Release Date	02/24/2026	Technical Service Bulletin		
96A1 UPDATE Replace Dynamic Light Strip – (NVLW)

Applicable Vehicles				
Country	Beginning Model Year	Ending Model Year	Vehicle	Vehicle Count
USA	2025	2025	ID. BUZZ	344
CAN	2025	2025	ID. BUZZ	5

Revision History		
Revision	Date	Purpose
2	August 13, 2026	Added GFF and battery charge labor operations to the claiming section due to a change in the ELSA repair manual
1	February 24, 2026	Original publication

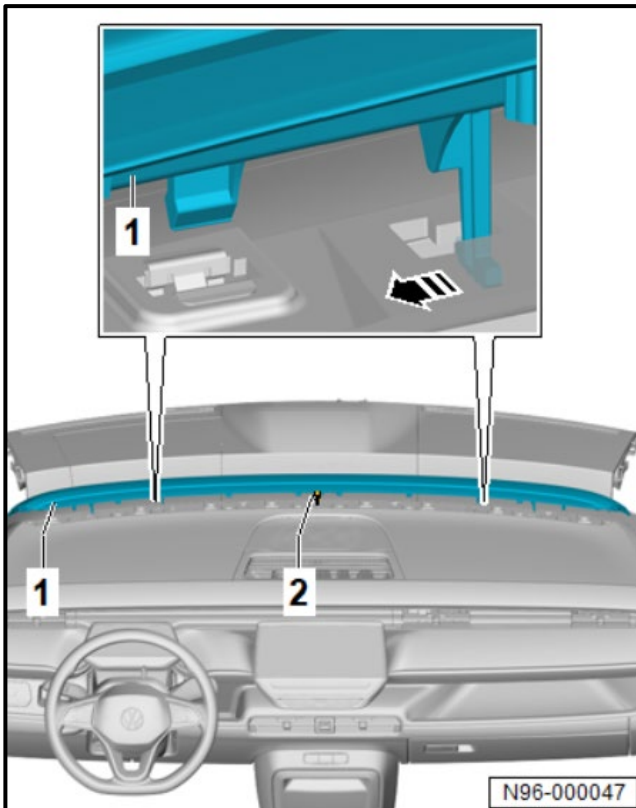
Test dynamic light strip operation:

- Observe the operation of the dynamic light strip while unlocking and locking the vehicle using the key fob.
 - The dynamic light strip should cycle green <arrow A> towards the outside of the vehicle when unlocking.
 - The dynamic light strip should cycle amber <arrow B> towards the center of the vehicle when locking.
- If the dynamic light strip operates as described above:
 - No further repairs are required, proceed to the claiming section.
- If the dynamic light strip does not operate as described above and/or only displays a faint white light in the corners <arrow>:
 - Replace the dynamic light strip using the instructions below.

- Replace the dynamic light strip per the ELSA repair manual:
 - *Repair manual > Electrical System > Electrical Equipment > 96 Interior Lights, Switches > Lamps > Dynamic Information Lighting Strip 3 L385, Removing and Installing.*
- Reassemble the vehicle in the reverse order of removal.
